- Change of the plastic screw nut for mounting

Product Change Notification					PCN Plastic Screw Nut Harmonisation		
owner	creation date	release date	released by	change order no	rev	page	D10-032-450
rescalfa	29.11.2018	06.12.2018	pingelme	2016800	A	1 of 8

3 Detailed description of change

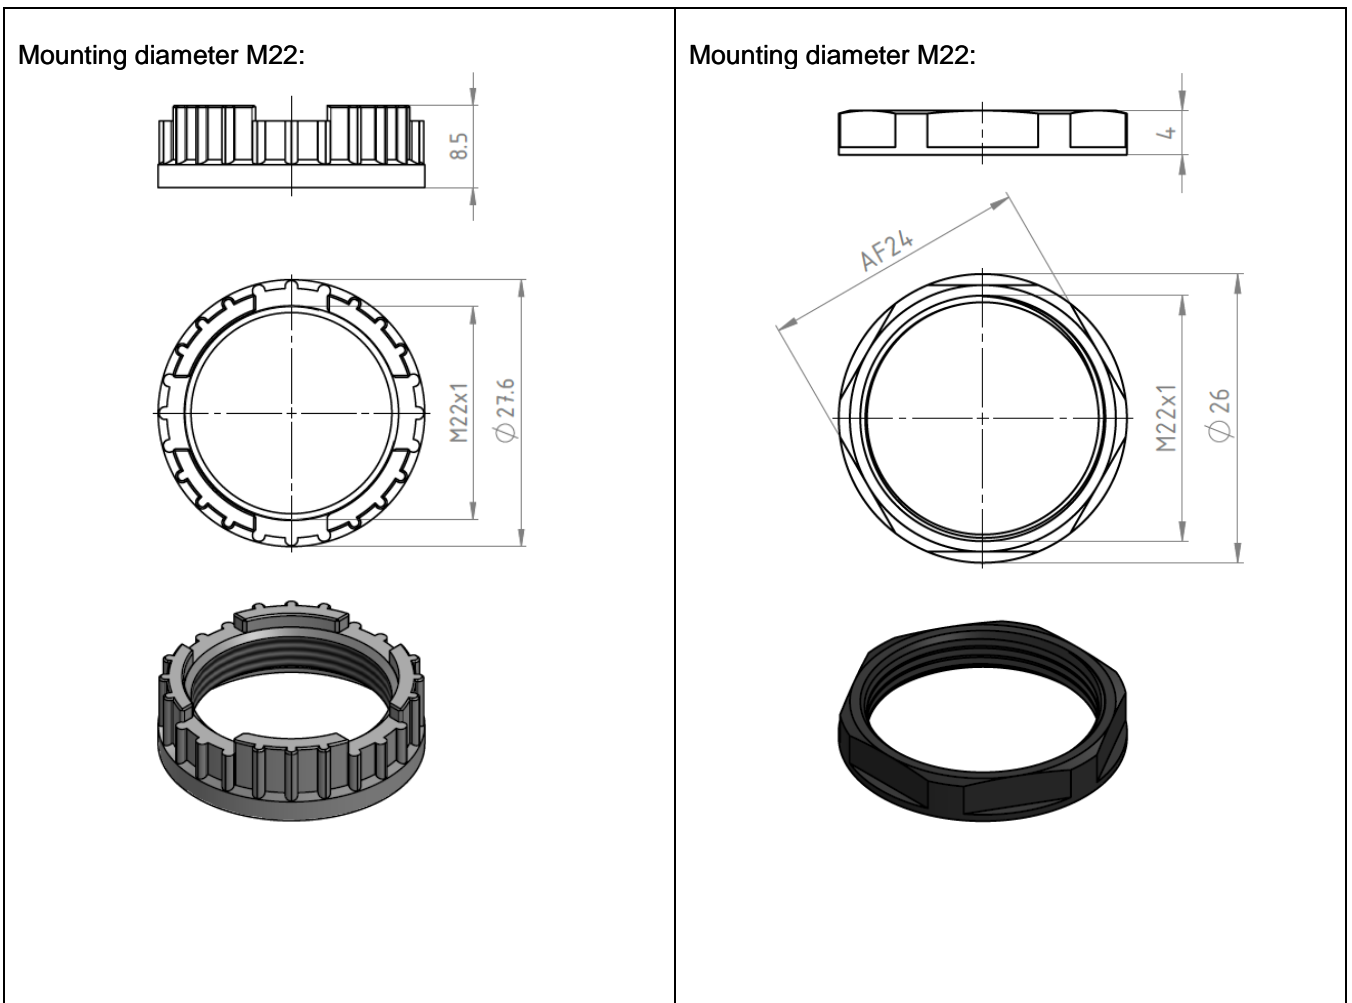
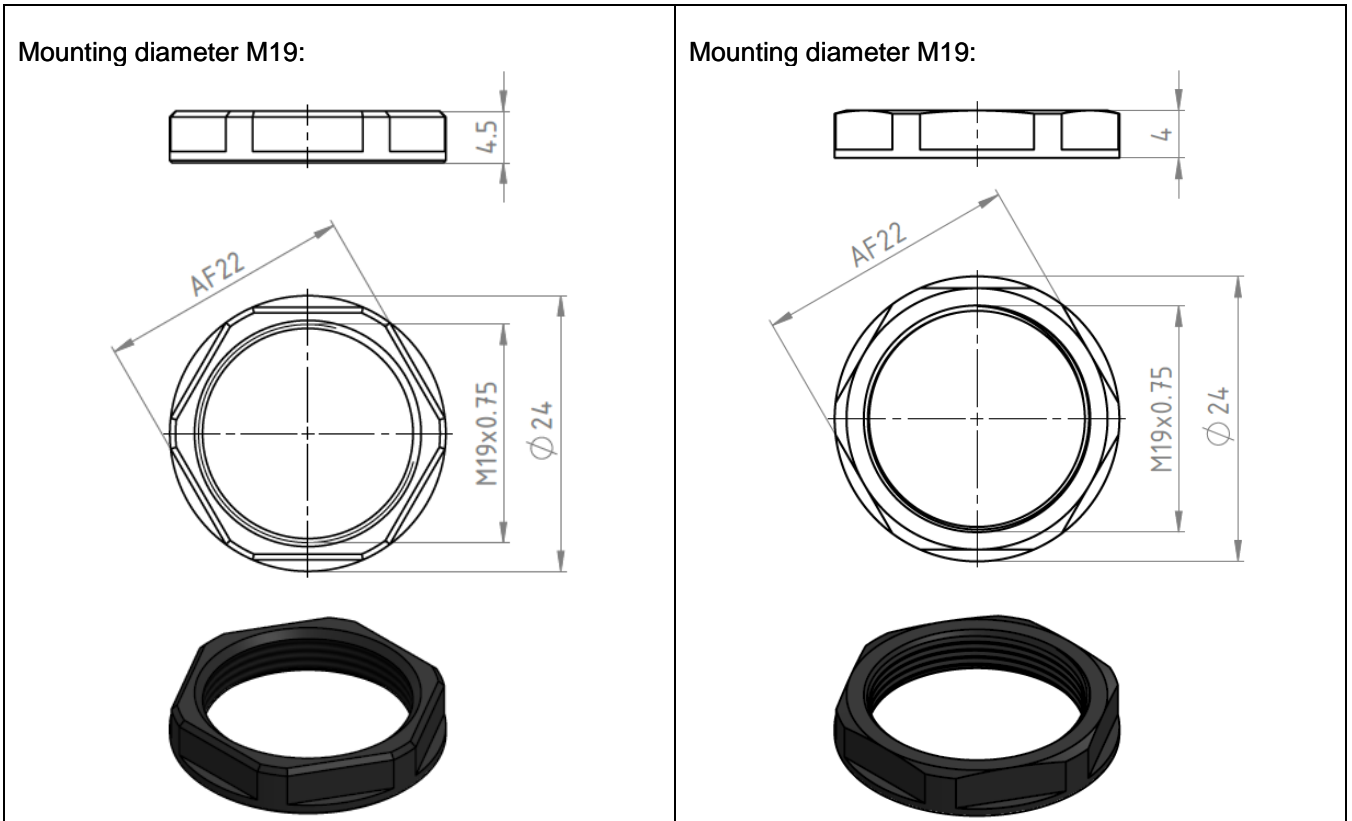
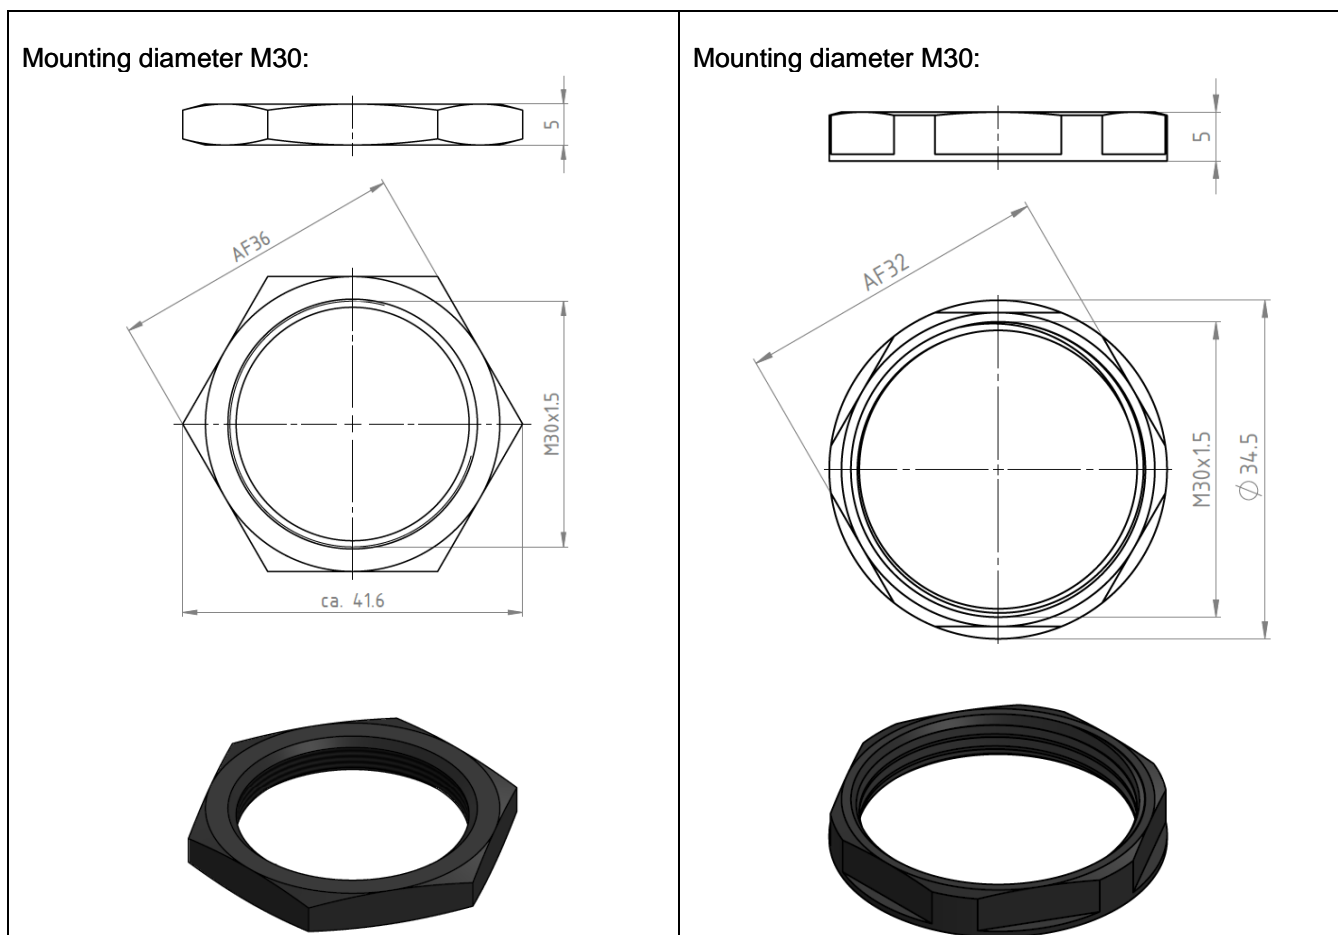
Old screw nut dimension and appearance	New screw nut dimension and appearance
<p>Mounting diameter M16:</p>	<p>Mounting diameter M16:</p>
